UNITED STATES PATENT AND TRADEMARK OFFICE

APPLICATION NO.	FILING DATE	FIRST NAMED INVENTOR	ATTORNEY DOCKET NO.	CONFIRMATION NO.
10/520,463	10/07/2005	Agostino Di Trapani	Q85687	5533
23373 7590 12/19/2006 SUGHRUE MION, PLLC 2100 PENNSYLVANIA AVENUE, N.W. SUITE 800 WASHINGTON, DC 20037			EXAMINER FONSECA, JESSIE T	
			ART UNIT 3637	PAPER NUMBER

**Office Action Summary**

### **DETAILED ACTION**

Figure 8: Komasa et al. (US 6,240,693)

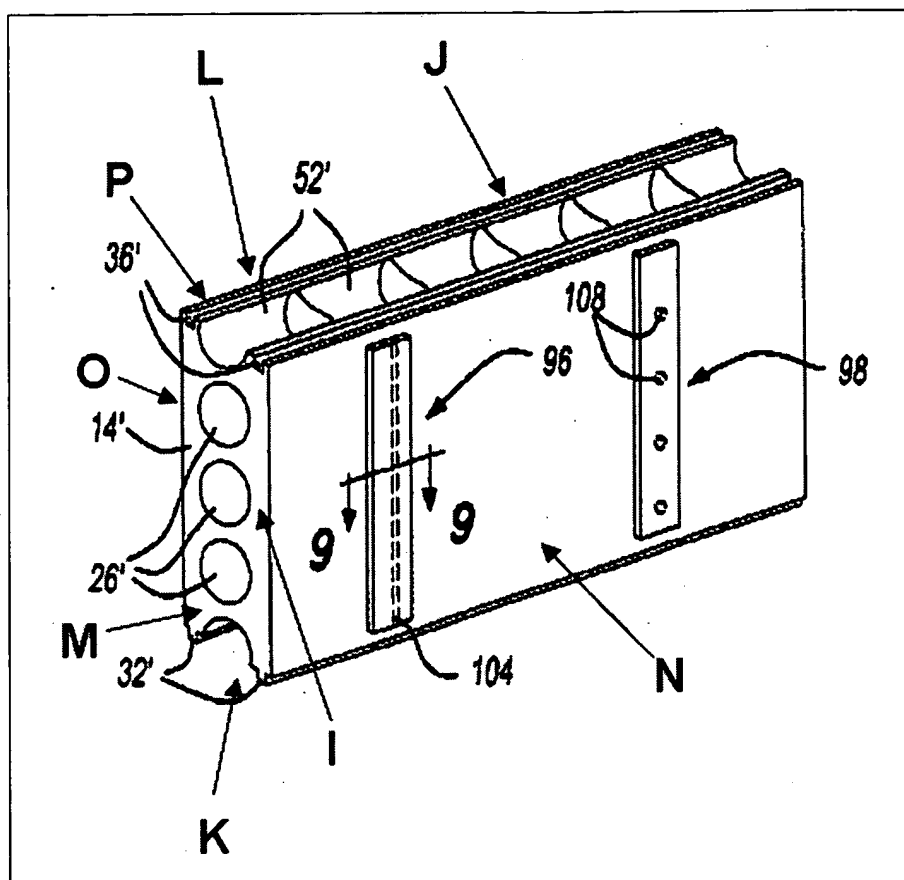
Claims 20 are rejected under 35 U.S.C. 102(b) as being anticipated by Komasara et al. (US 6,240,693).

Komasara et al. discloses construction element comprising:

An upper face (L), lower face (K), and lateral faces (M, N, O) where the construction element (J) comprises at least one groove or mortise (36'), capable of

having the application by grading a binder needed for the assembly of construction elements to one another. The mortise (36') extending over the upper face (L) of the construction element (J), where the construction element (J) comprises at least one protuberance or tenon (32'), which extends over the lower face (K) of the construction element. The mortise (36') is arranged in such a way to correspond with a tenon (32') of the similar construction element (J) so as to allow for the assembly of two construction elements (J). The mortise (36') is associated with a load-bearing wall (I) of the construction element (J) and is arranged a distance from the outer lateral edge (P) of the construction element (J). All the limitations regarding the binder has little patentable weight, as the binder relates to an intended use with a construction element as recited, "The distance of mortise being arranged from the outer lateral edge of the construction element, which is sufficient to prevent the overflow of binder beyond the edge of the element during assembly, characterized in that the mortise and the tenon are dimensioned in such a way as to allow, during the assembly of two elements, for a partial embedding such as will allow for a strip of binder to be formed between the upper face and the lower face of the elements, the sole contact between the two superimposed elements therefore being by way of this strip so as to allow for an adjustment of the alignment, of the height, and of the plumb alignment of the elements which are to be assembled."

With regards to claim 22, Komasara et al. further discloses the depth of the mortise (36') and the height of the tenon (32') being approximately equal. The tolerance

will inherently be proportional to the depth of the mortise (36') and height of the tenon (32'), which is to be accommodated with the construction element (J).

With regards to claim 23, the ratio of the weight of the construction element (J) to the surface area of the small base of the trapezoidal of the tenon (32') will inherently be inversely proportional to the fluidity of the binder placed between two construction elements (J), so as to allow for proper alignment of the assembly.

With regards to claim 24, Komasara et al. discloses the width of the mortise (36') being less than the thickness of the load-bearing wall (I) or partition of the construction element (J) on which the mortise is placed.

With regards to claim 29, Komasara et al. further discloses a mortise (36') that is designed to accommodate equally a simple or straddle fitting (col. 9, lines 40-52).

With regards to claim 35, Komasara et al. discloses a wall constructed with a plurality of construction elements (J), where the wall is constructed with "thin joints" between the construction elements (figure 1) (col. 9; lines 40-52).

With regards to claim 36, Komasara et al. further discloses a wall that comprises the assembly of the construction elements (J), where each construction assembly comprises at least two preassembled construction elements (J) (col. 9, lines 40-52).

Figure 3: Roberts (US 822,078)

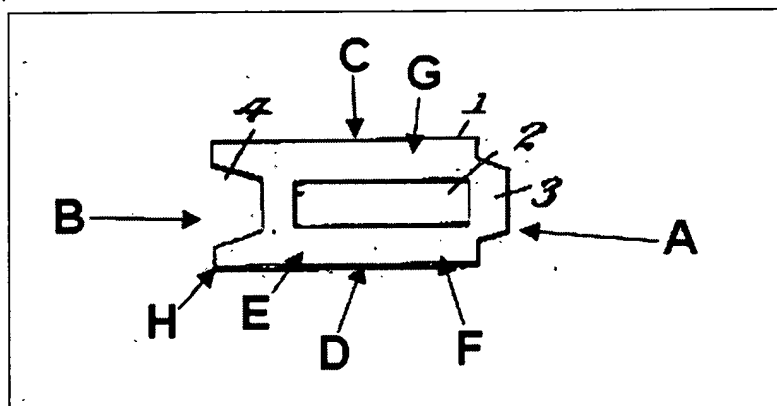
Claims 20-23, 29, 35-36 are rejected under 35 U.S.C. 102(b) as being anticipated by Roberts (US 822,078).

**Roberts discloses construction element comprising:**

An upper face (B), lower face (A), and lateral faces (C, D, E) where the construction element (F) comprises at least one groove or mortise (4), capable of having the application by grading a binder needed for the assembly of construction elements to one another. The mortise (4) extending over the upper face (B) of the

construction element (F), where the construction element (F) comprises at least one protuberance or tenon (3), which extends over the lower face (A) of the construction element. The mortise (4) is arranged in such a way to correspond with a tenon (10) of the similar construction element (F) so as to allow for the assembly of two construction elements (F). The mortise (4) is associated with a load-bearing wall (G) of the construction element (F) and is arranged a distance from the outer lateral edge (H) of the construction element (F). All the limitations regarding the binder has little patentable weight, as the binder relates to an intended use with a construction element as recited, "The distance of mortise being arranged from the outer lateral edge of the construction element, which is sufficient to prevent the overflow of binder beyond the edge of the element during assembly, characterized in that the mortise and the tenon are dimensioned in such a way as to allow, during the assembly of two elements, for a partial embedding such as will allow for a strip of binder to be formed between the upper face and the lower face of the elements, the sole contact between the two superimposed elements therefore being by way of this strip so as to allow for an adjustment of the alignment, of the height, and of the plumb alignment of the elements which are to be assembled."

With regards to claim 22, Roberts further discloses the depth of the mortise (4) and the height of the tenon (3) being approximately equal. The tolerance will inherently be proportional to the depth of the mortise (4) and height of the tenon (3), which is to be accommodated with the construction element (F).

With regards to claim 23, The ratio of the weight of the construction element (F) to the surface area of the small base of the trapezoidal of the tenon (6) will inherently be inversely proportional to the fluidity of the binder placed between two construction elements (F), so as to allow for proper alignment of the assembly.

With regards to claim 29, Roberts further discloses a mortise (4) that is designed to accommodate equally a simple or straddle fitting (figure 1).

With regards to claim 35, Roberts discloses a wall constructed with a plurality of construction elements (F), where the wall is constructed with “thin joints” between the construction elements (figure 1).

With regards to claim 36, Roberts further discloses a wall that comprises the assembly of the construction elements (F), where each construction assembly comprises at least two preassembled construction elements (F).
